## **CERTIFICATE OF APPROVAL DOWNTOWN DESIGN REVIEW DISTRICT DTCA-22-00032 REVISION #1**

HUDSON OFFICE BUILDING  
 11<sup>th</sup> and Hudson  
 Oklahoma City, Oklahoma 73104  
 Project No. 2109

**DDRC REVISION**

**1 1ST FLOOR -FLOOR PLAN**  
P1.01 SCALE: 1/16" = 1'-0"

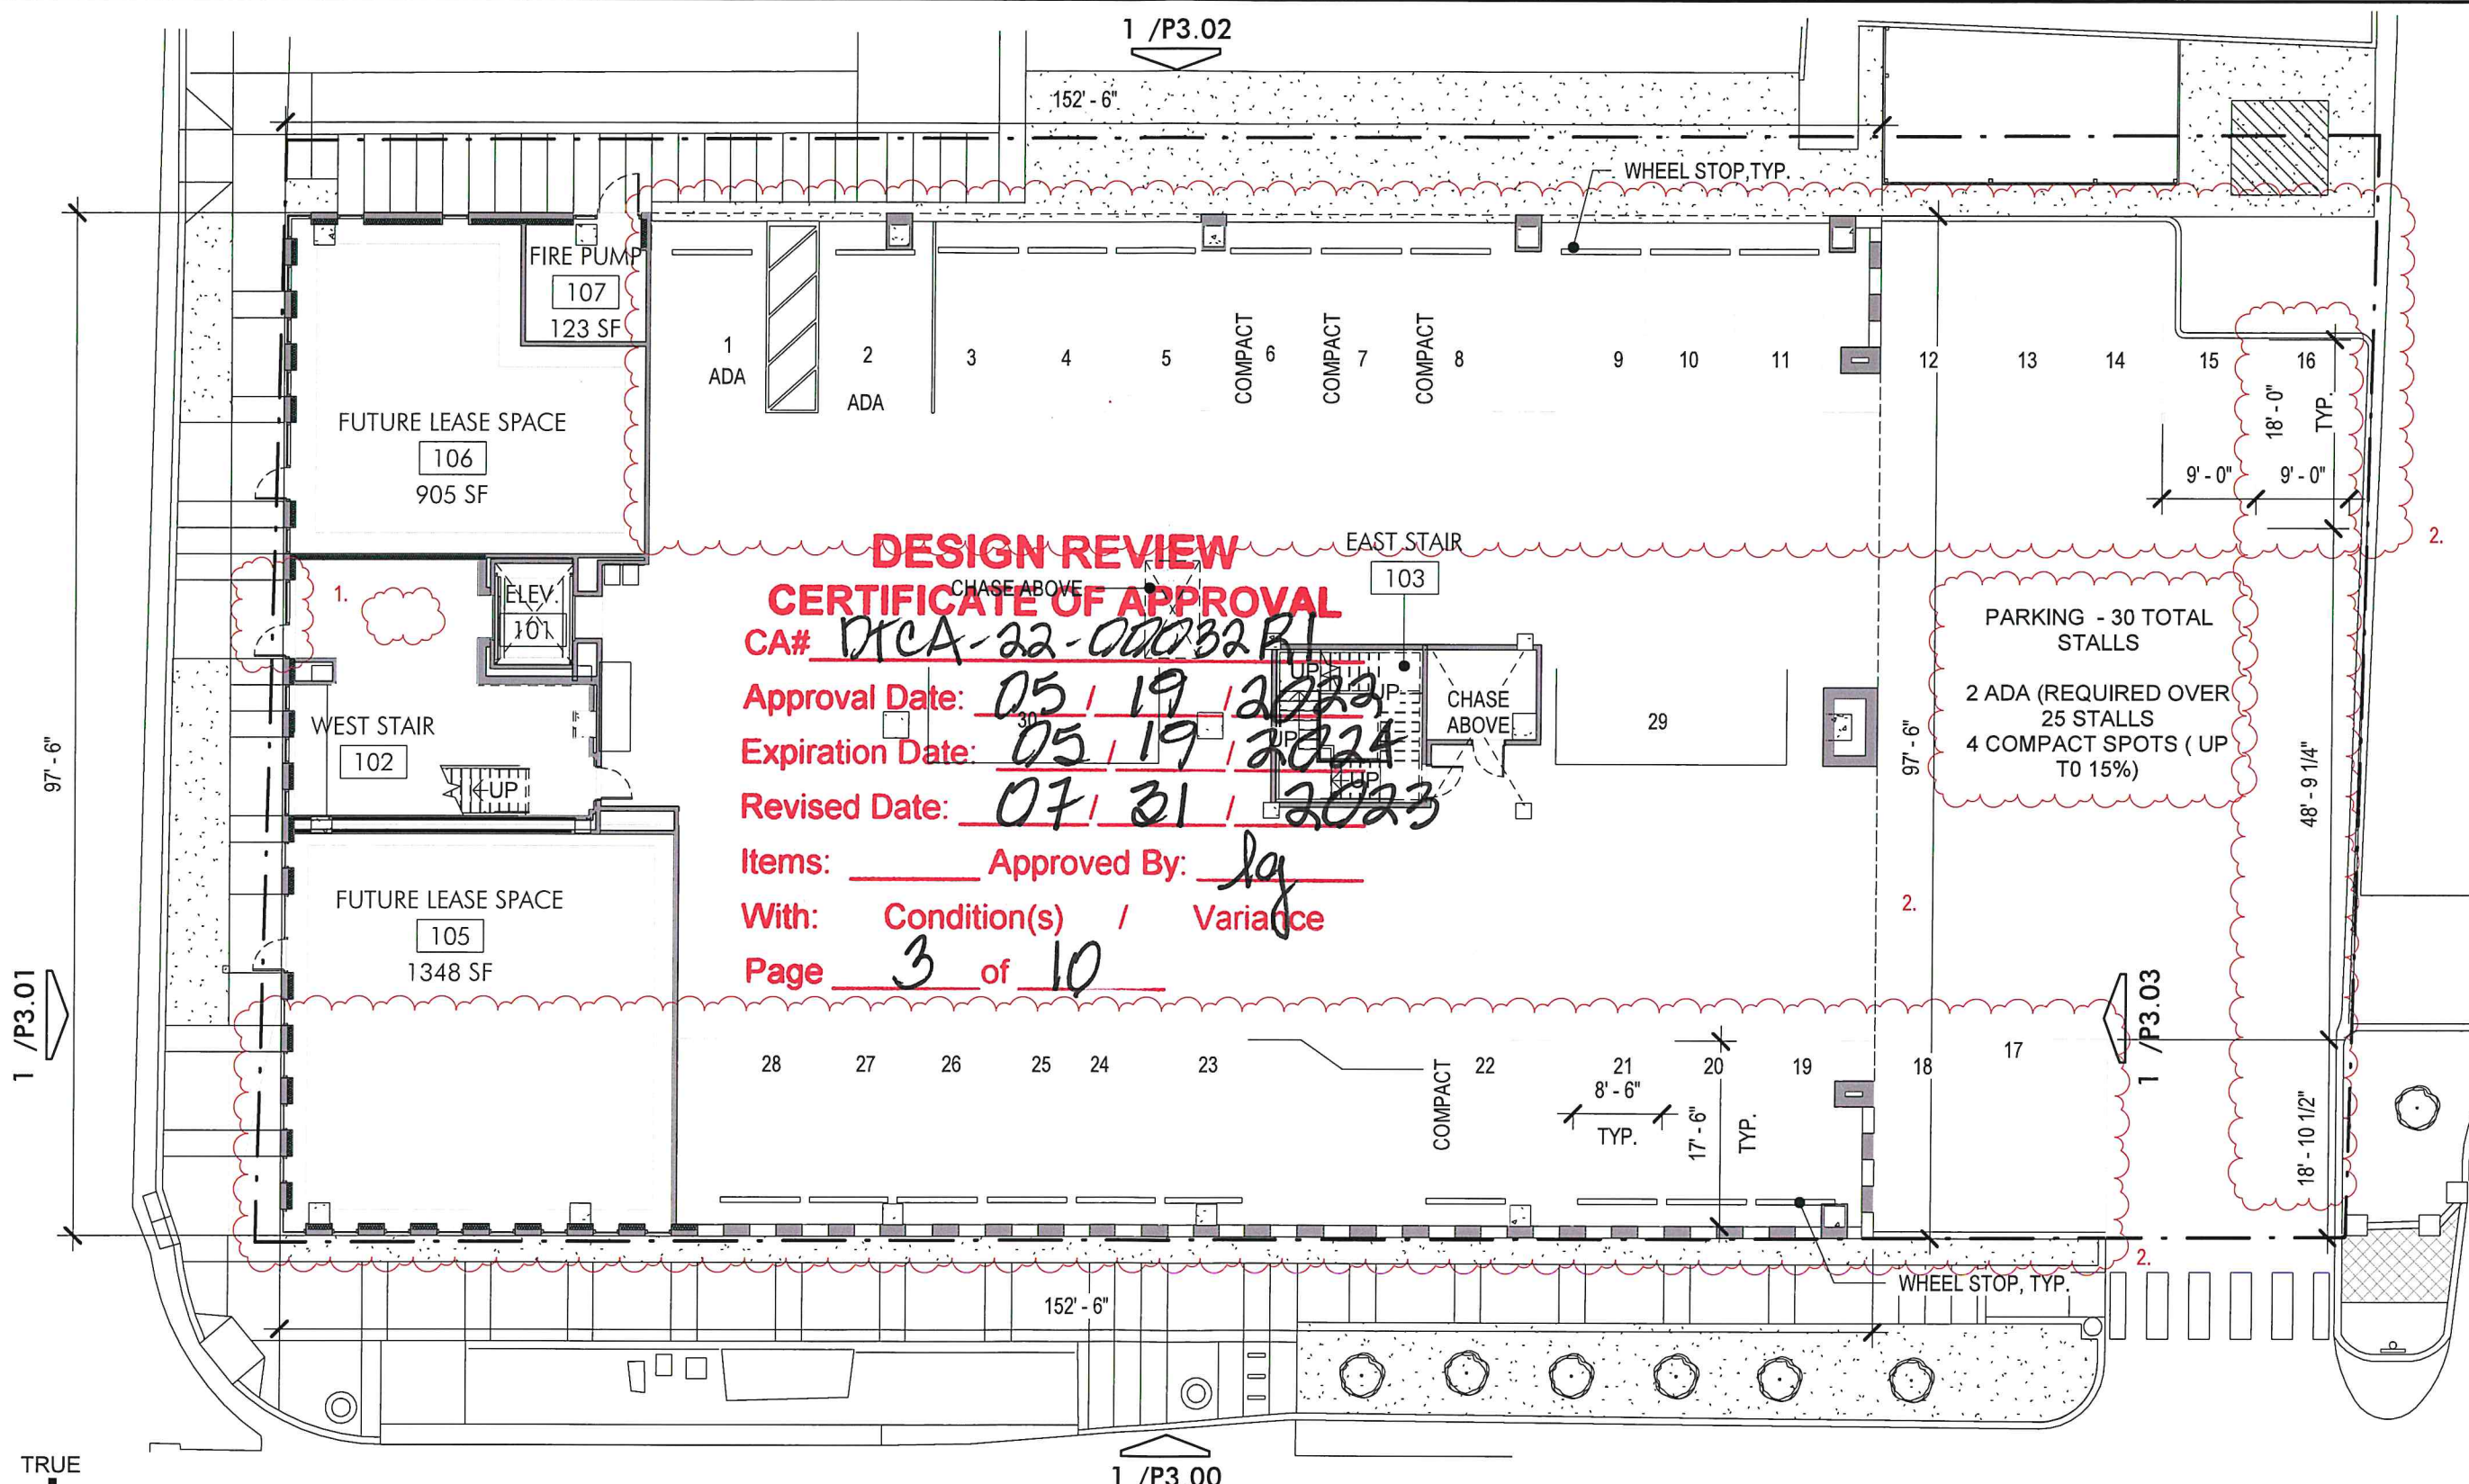
P1.00	1. Located new North Property line. 2. Electric company requires larger clearance in front of equipment. Curbs & parking reconfigured. 3. Remote FDC located with-in 100'-0" existing fire hydrant required by planning review. Relocated 63' to the South. 4. Existing streetcar stop "panels" integrally poured with curb. The city will not allow these panels to be modified requiring job in south curb line. 5. Existing streetcar stop grades will not allow south retail entry. 6. Light levels from parking do not require parking poles. 7. Occupancy load does not require double door on west façade at lobby.
P1.01	1. Occupancy load does not require double door on west façade at lobby. 2. Code review required rework of parking spots.
P1.02	1. Relocated Gym.
P1.04	1. Removed Future Tenant room tags.
P3.00	1. Bay window location adjusted for façade aesthetic balance after removal of south retail entry. 2. Reworked façade at south retail entry. 3. Lower mullion not required for glazing performance and removed due to cost.

**1 EXTERIOR ELEVATION - SOUTH**

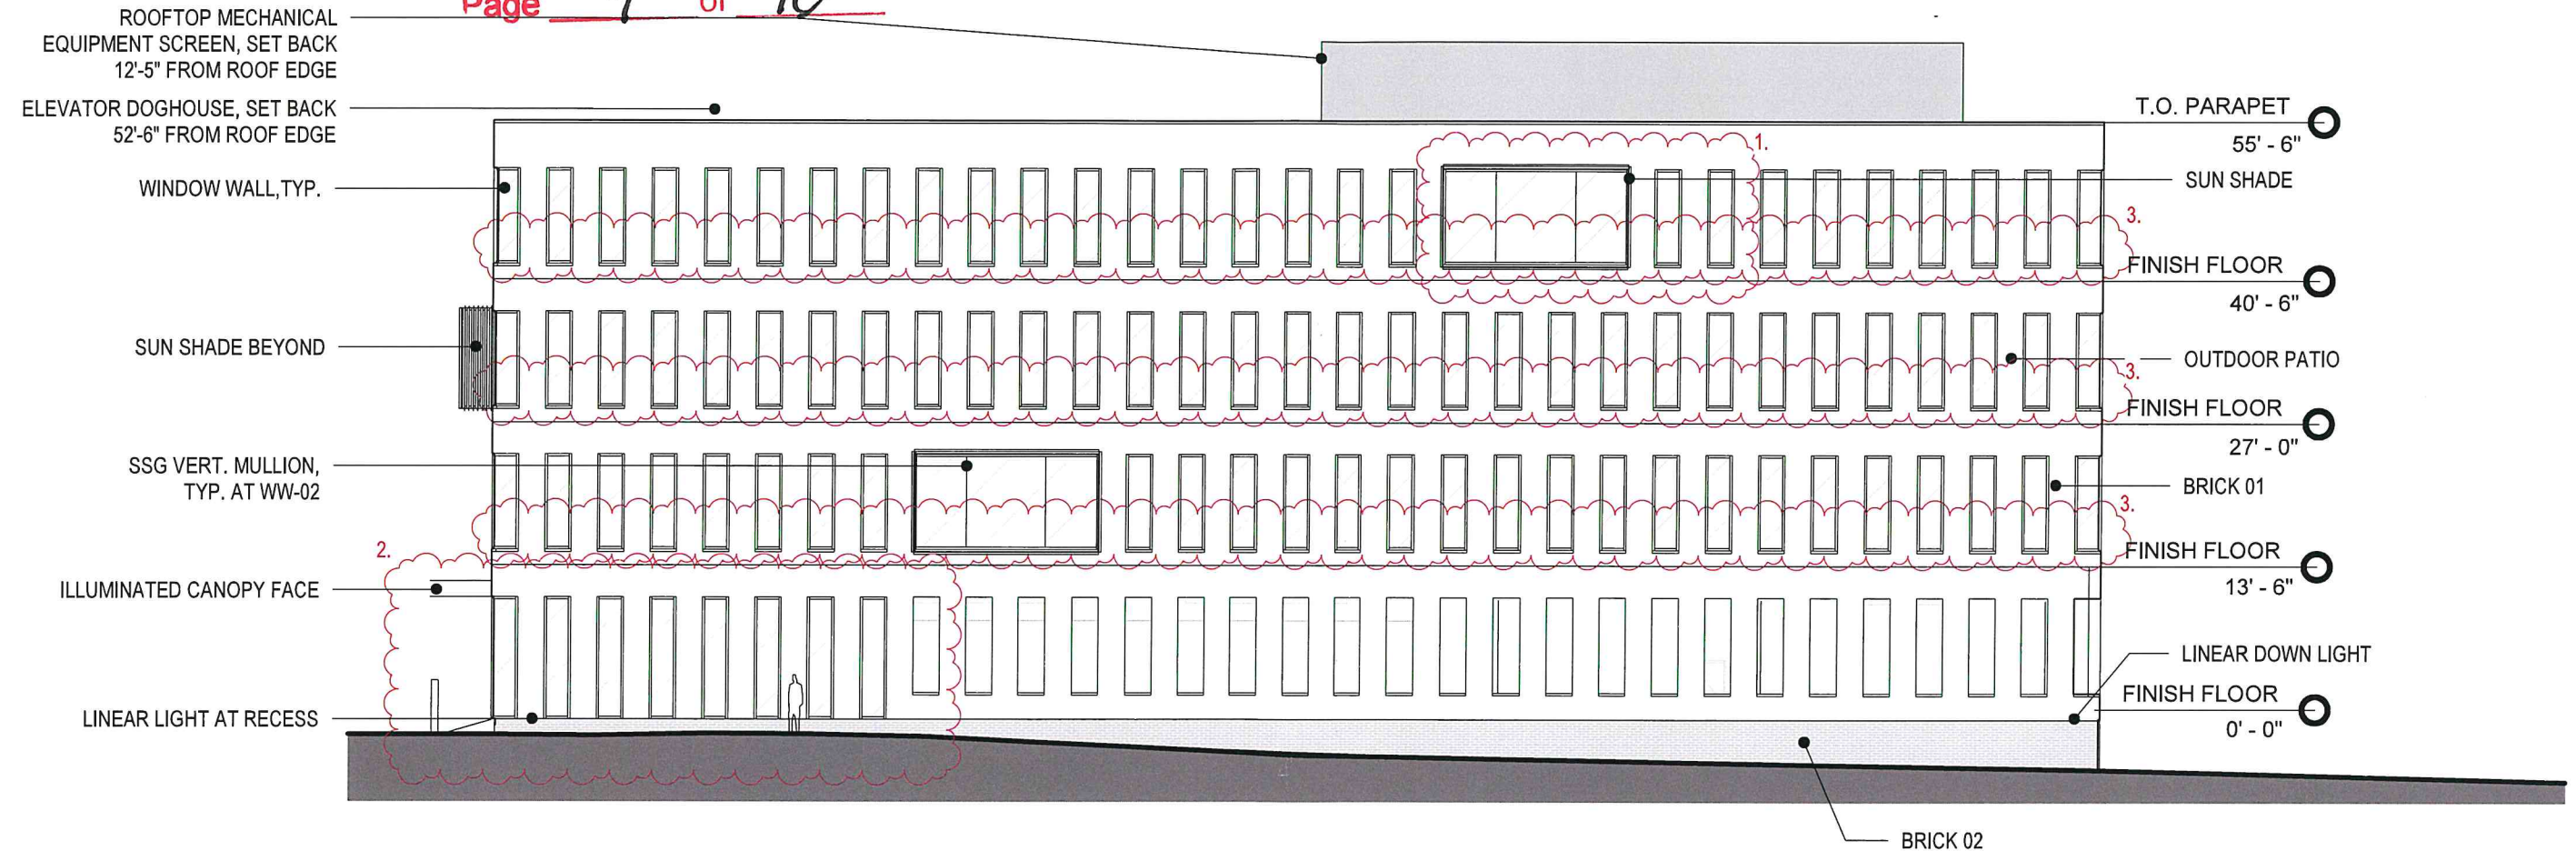
P3.01	1. Occupancy load does not require 2 doors on west façade. 2. Reworked façade at south retail entry due to removal of entry. 3. Lower mullion not required for glazing performance and removed due to cost, typical at all punched openings.
P3.02	1. Lower mullion not required for glazing performance and removed due to cost, typical at all punched openings. 2. Window openings reduced by 50% due to cost. This on the alley side of building with existing building covering 50% of façade. 3. Grow wall moved to alternate due to cost.
P3.03	1. Sunshade note beyond does not show in cut. 2. Lower mullion not required for glazing performance and removed due to cost, typical at all punched openings.

35.42 SQ. FT OF MULLION REMOVED

135 SQ. FT OF FIRST FLOOR.

90 SQ. FT CHANGE TO OUTDOOR PATIO ALTERNATE

**1 EXTERIOR ELEVATION - EAST**

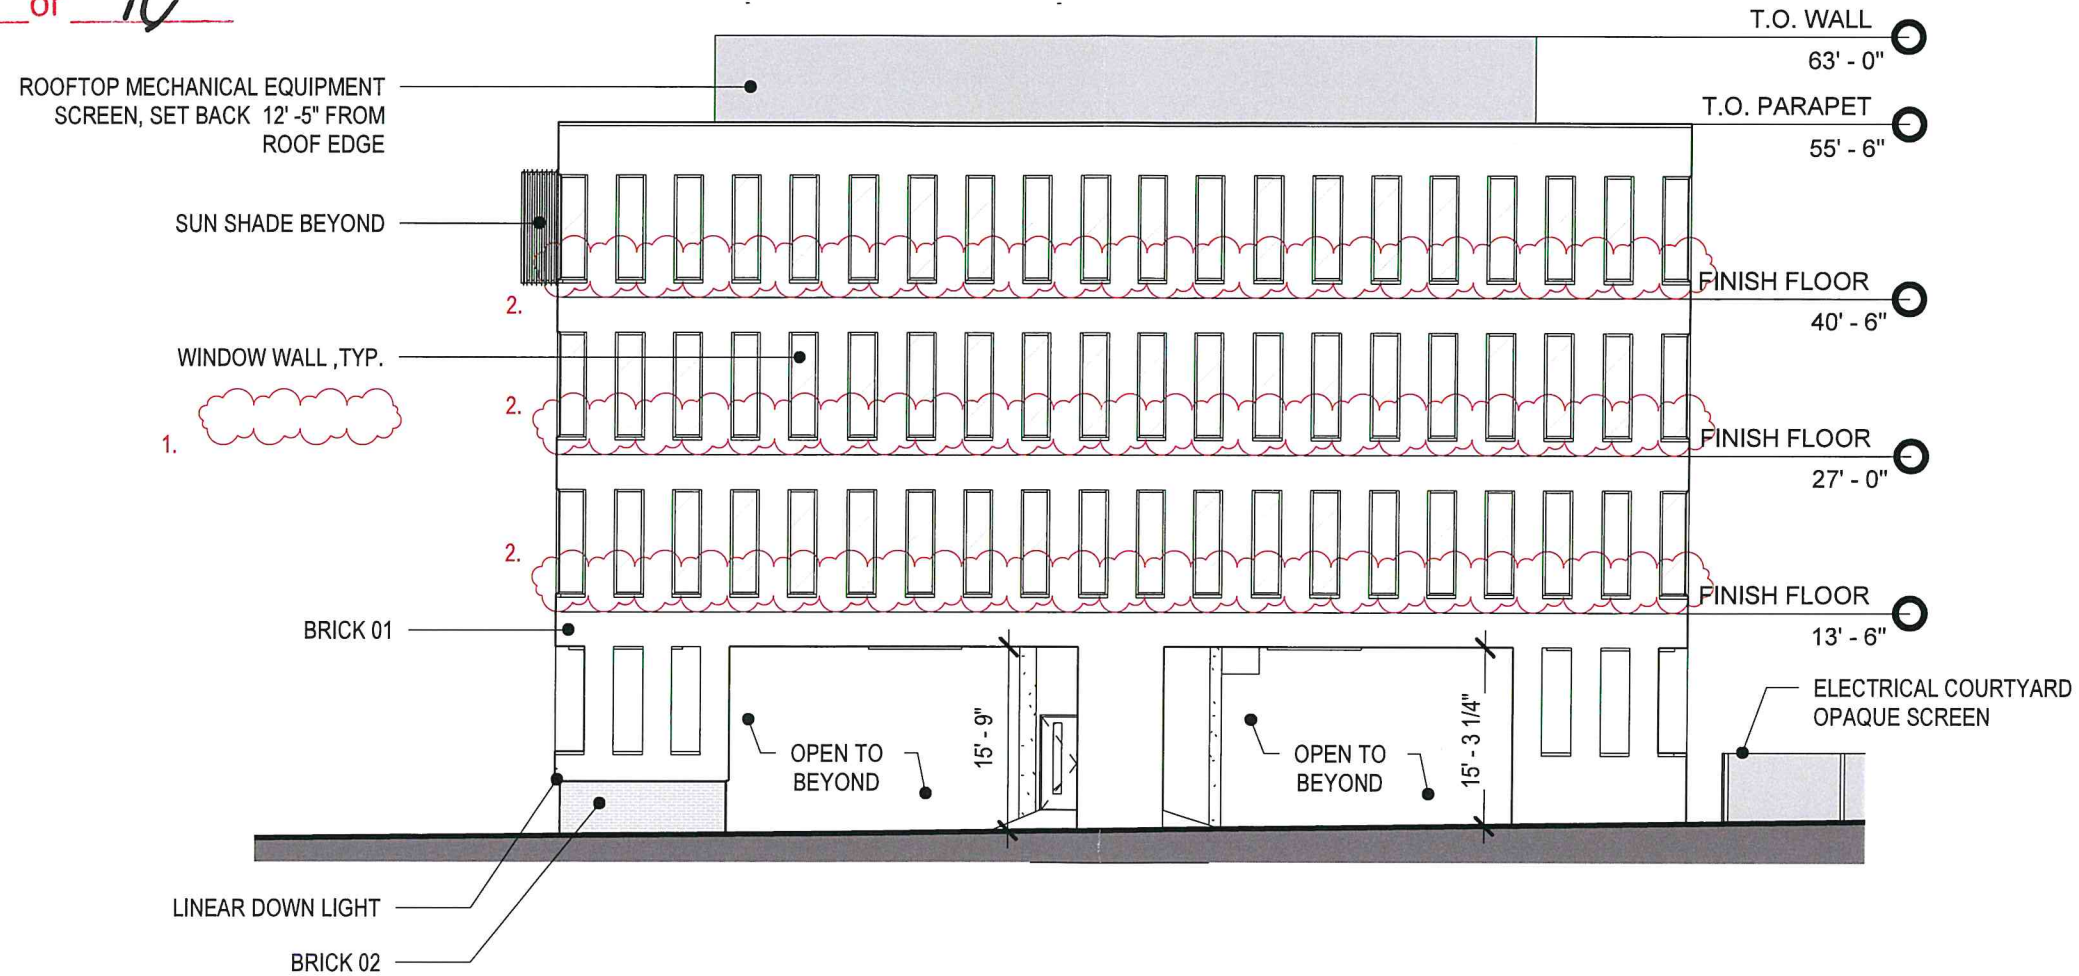
25 SQ. FT OF MULLION REMOVED
